TENNESSEE VALLEY AUTHORITY

ENCLOSURE
WATTS BAR NUCLEAR PLANT UNITS 1 AND 2
REQUEST FOR ADDITIONAL INFORMATION
SAFETY PARAMETERS DISPLAY SYSTEM

420.01 Isolation Devices

FIGURE 1

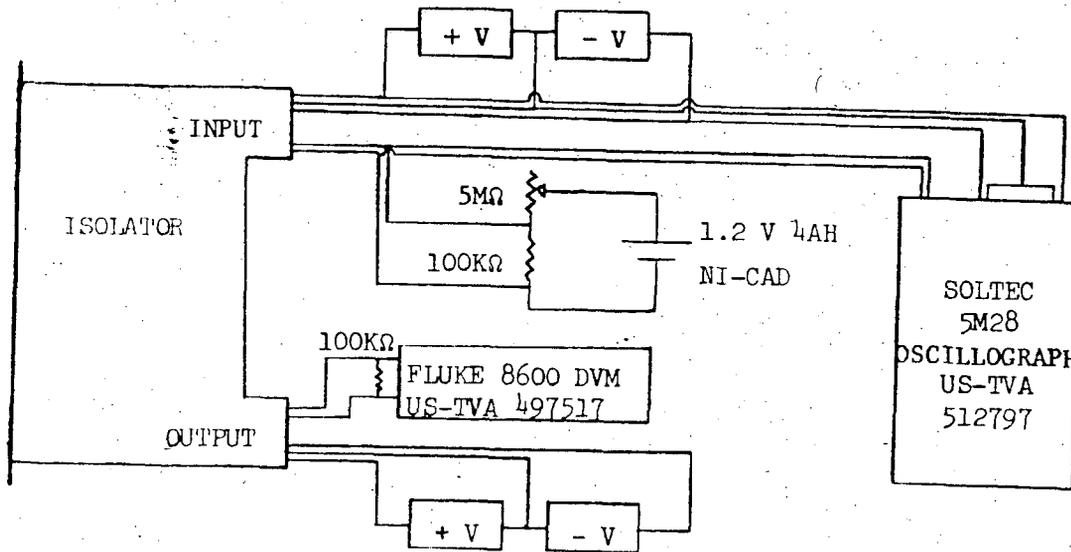
- a. For each type of device used to accomplish electrical isolation, describe the specific testing performed to demonstrate that the device is acceptable for its application(s). This description should include elementary diagrams when necessary to indicate the test configuration and how the maximum credible faults were applied to the devices.

- c. Data to verify that the maximum credible fault was applied to the output of the device in the transverse mode (between signal and return) and other faults were considered (i.e., open and short circuits).

The circuit shown in Figure 1 was used to obtain reference data representing normal operating conditions. This configuration was used prior to beginning the test sequence and after each fault application. Operating power (+V and -V) was supplied by four 12-volt (nominal) 1.2 amp hour nickel-cadmium battery packs.

Batteries were used to provide operating power to insure total isolation. A battery and resistor network was used to supply the 0 to 100 mv input signal, and to provide an approximate 100 KΩ input impedance. Using this configuration, and with input voltages of 0, 50, and 100 mv, nominal readings were taken on each isolator at the output and each signal test point provided on the circuit board. Although only one unit (S/N 0114) was tested to the point of destruction, each unit was operationally checked. All outputs were found to be within specified tolerance and test point measurements were similar from unit to unit. Test point 7 was not used as it is the same electrical point as the output terminal.

Sketch RS 527A

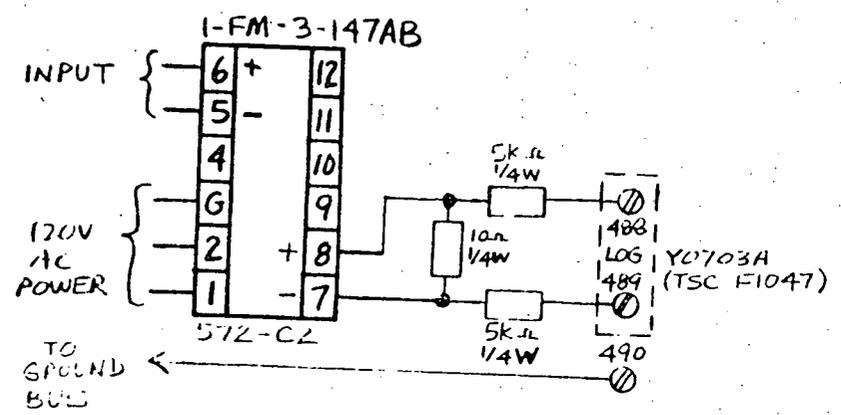
- b. Data to verify that the maximum credible faults applied during the test were the maximum voltage/current to which the device could be exposed, and define how the maximum voltage/current was determined.

Attached sketch RS527A shows the isolating device with respect to cabling leaving the isolator cabinet.

Also shown on this sketch is a resistor network in the isolating device output circuit which increases the circuit impedance as seen from the remote terminal of the interconnecting signal cable. During normal operation an open or short circuit in the output circuit side of the resistor network would have no effect on the input circuit current loop. The high impedance of the two series 5k-ohm resistors essentially presents an open circuit in the output cable; whereas, the 10-ohm shunt resistors offer a low impedance path for the isolator output current regardless of the type of fault the output signal cable may experience. Should the maximum credible voltage (120V ac) be applied directly across the two signal conductors, the maximum current to flow would be 0.012 amperes. This is due to the 10k ohms of series resistance in the signal circuit. This current would be too low to be detected by the protective devices in the fault source voltage. Should the fault not be detected by erratic indications at the remote terminal and persist long enough, the low wattage series resistors would open up the signal output circuit. Any disturbances due to arcing or fault current feed into the internal output circuit of the isolator would have no effect on the input circuit current loop due to the transformer isolating design of the device. Attached Robertshaw product specification sheet and internal schematic diagram illustrate the isolating construction of the device.
